**PCN#20160602000A  
BGA Tray Change  
Final Change Notification**

<b>PCN Number:</b>	20160602000A	<b>PCN Date:</b>	06/20/2016
<b>Title:</b>	BGA Tray Change		
<b>Customer Contact:</b>	<a href="#">PCN Manager</a>	<b>Dept:</b>	Quality Services
<b>Change Type:</b>	<input type="checkbox"/> Assembly Site <input type="checkbox"/> Assembly Process <input type="checkbox"/> Assembly Materials <input type="checkbox"/> Design <input type="checkbox"/> Electrical Specification <input type="checkbox"/> Mechanical Specification <input type="checkbox"/> Test Site <input checked="" type="checkbox"/> Packing/Shipping/Labeling <input type="checkbox"/> Test Process <input type="checkbox"/> Wafer Bump Site <input type="checkbox"/> Wafer Bump Material <input type="checkbox"/> Wafer Bump Process <input type="checkbox"/> Wafer Fab Site <input type="checkbox"/> Wafer Fab Materials <input type="checkbox"/> Wafer Fab Process <input type="checkbox"/> Part number change

#### Group 1 Device: 9x9mm BGA Tray

**Group 2 Device: 10x10mm BGA Tray**

### TRAY DESIGN CONSIDERATION and COMPARISON

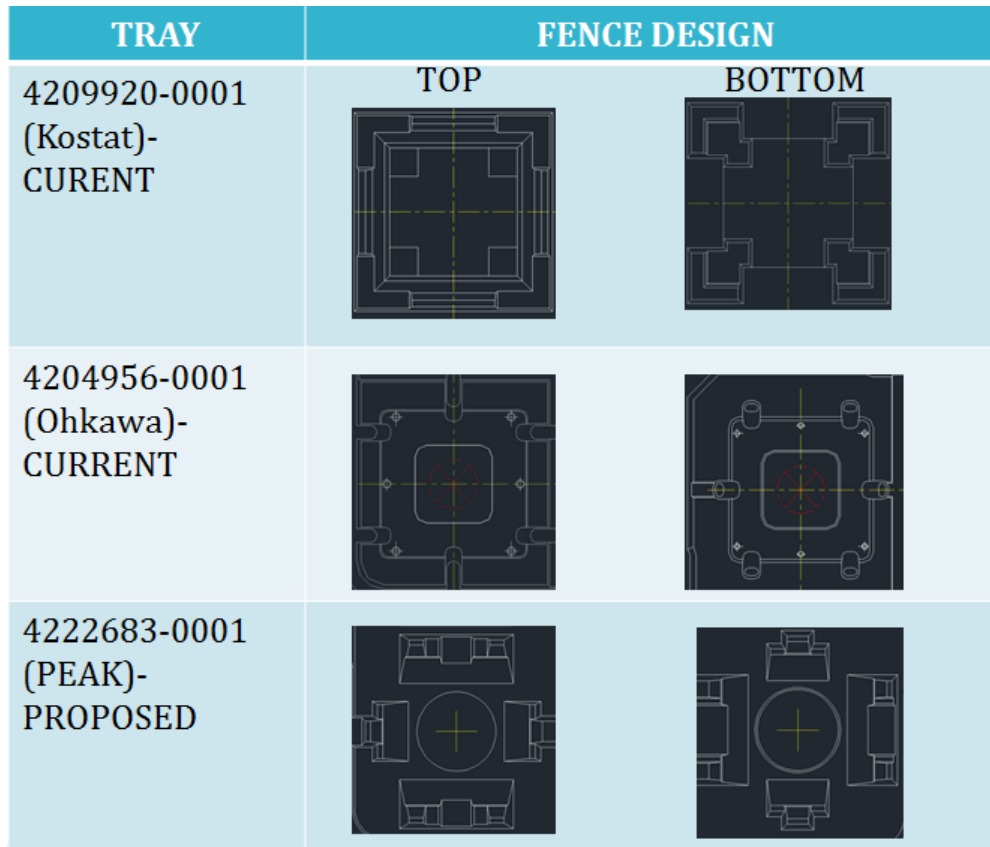
TRAY	POCKET OPENING
4209920-0001 (Kostat)- CURRENT	 <p>Sharp edges on the pocket opening that may cause chipping</p>
4204956-0001 (Ohkawa)- CURRENT	 <p>Circular pocket opening</p>
4222683-0001 (PEAK)- PROPOSED	 <p>Circular pocket opening</p>

### Dimensional Comparison:

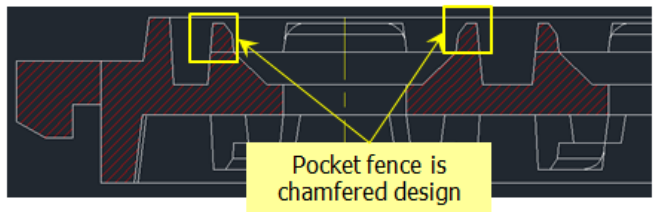
Stack Height	1.27	1.40	1.14	1.27	1.40	1.14	1.27	1.40	1.14	SAME
Tray Matrix No.	10x26			8x21			10x26			CHANGE
Pitch M	10.35	10.48	10.22	10.55	10.68	10.42	10.35	10.48	10.22	CHANGE
Pitch M3	12.80	12.93	12.67	7.45	7.58	7.32	12.80	12.93	12.67	CHANGE
Pitch M1	10.00	10.13	9.87	10.00	10.13	9.87	10.00	10.13	9.87	CHANGE
Pitch M2	11.80	11.93	11.67	14.75	14.88	14.62	11.80	11.93	11.67	CHANGE
Cavity opening	12.75	12.88	12.62	11.03	11.16	10.90	14.18	14.31	14.05	CHANGE
Pedestal Design	SLOPE			PEDESTAL			SLOPE			CHANGE
Package seating height (Top)	1.50	1.63	1.37	1.40	1.48	1.32	1.50	1.60	1.40	CHANGE
Package seating height (Bottom)	1.62	1.75	1.49	1.70	1.78	1.62	1.50	1.60	1.40	CHANGE

**TRAY DESIGN CONSIDERATION and COMPARISON**

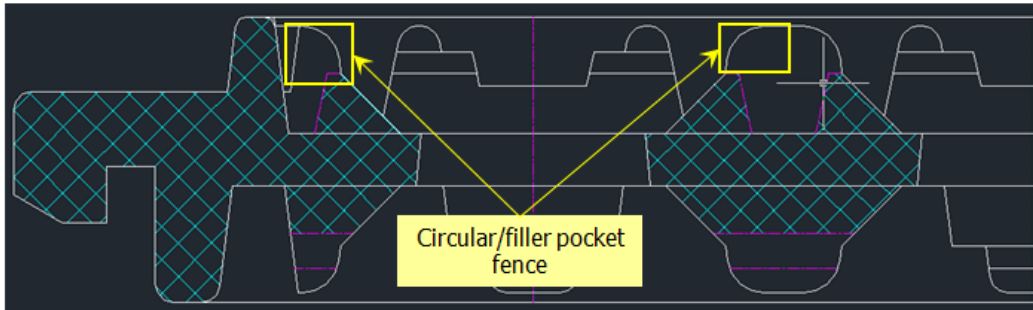
**Tray Pocket: Current**

**Tray Pocket: Proposed**
